# AERONAUTICAL ACCESSORIES, INC.

## ALERT SERVICE BULLETIN

### ASB No. AA-06066

**SUBJECT:** Flat Crew Window  
P/N 206-202-103 / 206-202-104 / 206-202-001 / 206-202-002

**FIGURE 1 – Identification**

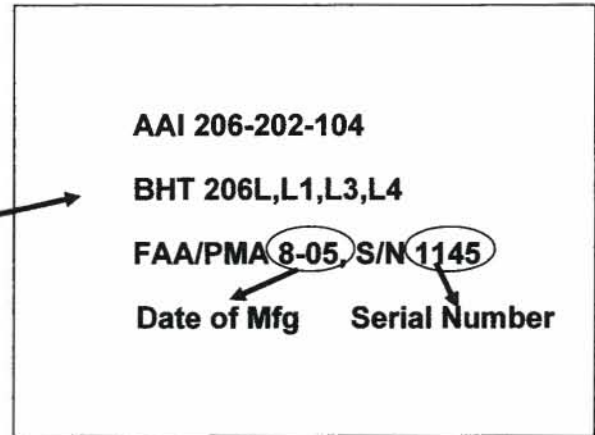
**COMPLIANCE:** Immediately upon receipt of this bulletin, determine by part number, serial number, and manufacture date (ref. Figure 1) if affected window(s) is (are) installed. Only those serial numbers listed are affected. A part with a serial number that is close to, or has a serial number prefix different from those listed is not affected by this bulletin. For installed windows, conduct Part I visual inspection within 8 hours; conduct Part II inspections within 24 hours. For uninstalled windows, accomplish Part I and Part II prior to installation on a helicopter.

**FIGURE 5 – Forward Pull Test Locations**

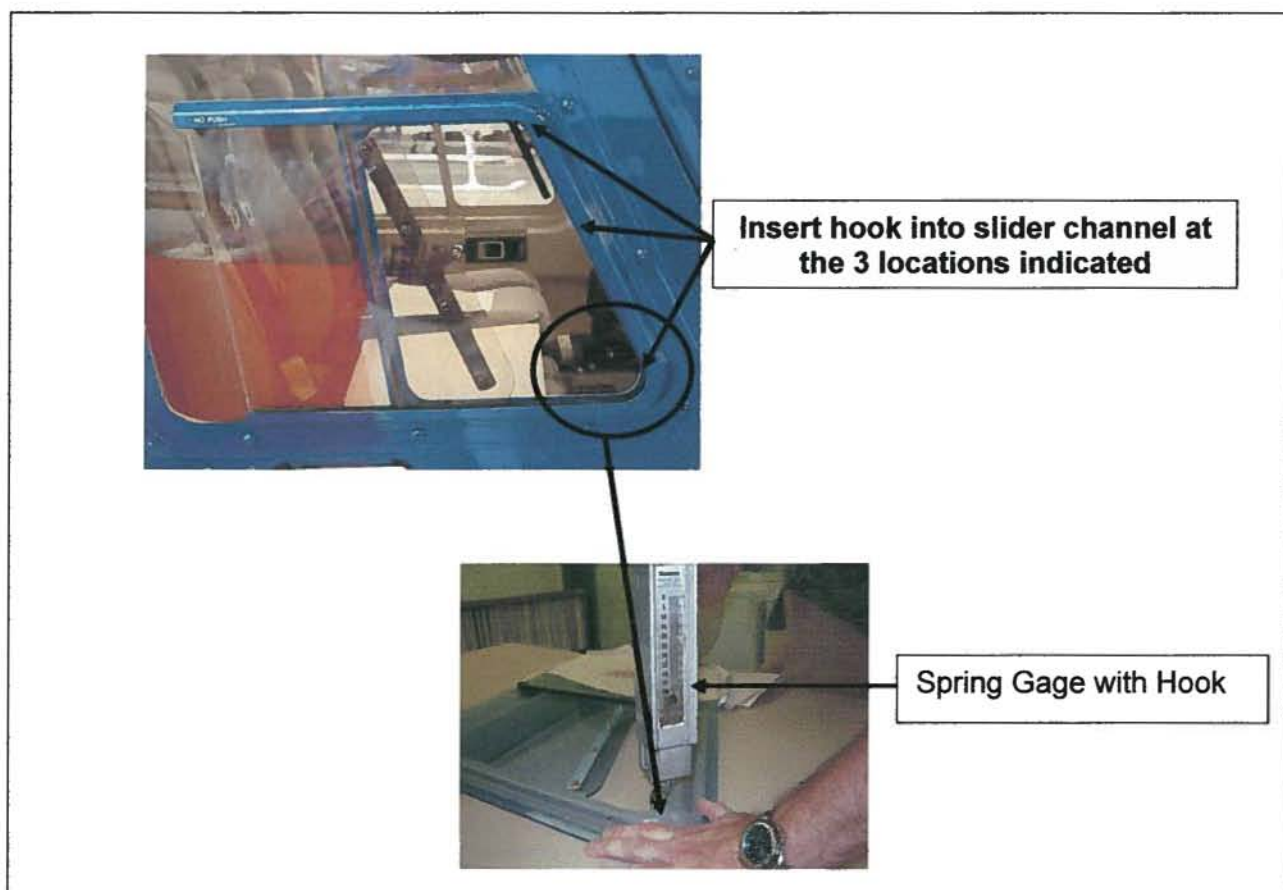
4. With the slider assembly in the full-open (aft) position, from the exterior of the aircraft, insert the spring hook directly into the channel of the slider track at the 3 locations indicated in Figure 5.

5. Using the spring gage, pull outward on the slider track (away from the acrylic) until the gage reads 25 lbs. Visually inspect the slider track for any obvious signs that the track is de-bonding from the acrylic.
